Access Compliance Report

Public Rights-of-Way

(Curb Ramps)

Intersection ID: 10014712	Main Street: NORLAND_RD	Cross Street: N/A	Location: S
ADA ID: D2BF9AA98886	Ramp Type: BlendTrans1	Initial Pass/Fail: Pass	Overall Compliance: No
		Severity Score: 7.5

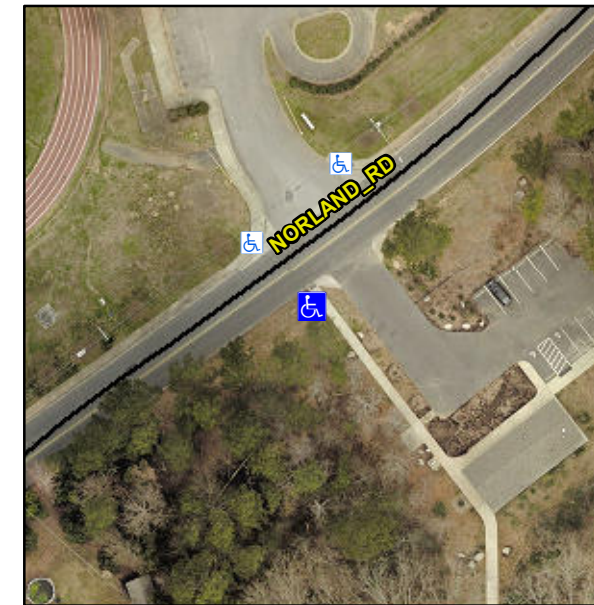
R304.2.2-Perp, R304.3.2-Para, R305.1.4, R305.2, R304.5.4

Remove & Replace Curb Ramp With Two New Directional Ramps or Equivalent. Remove & Replace Gutter.
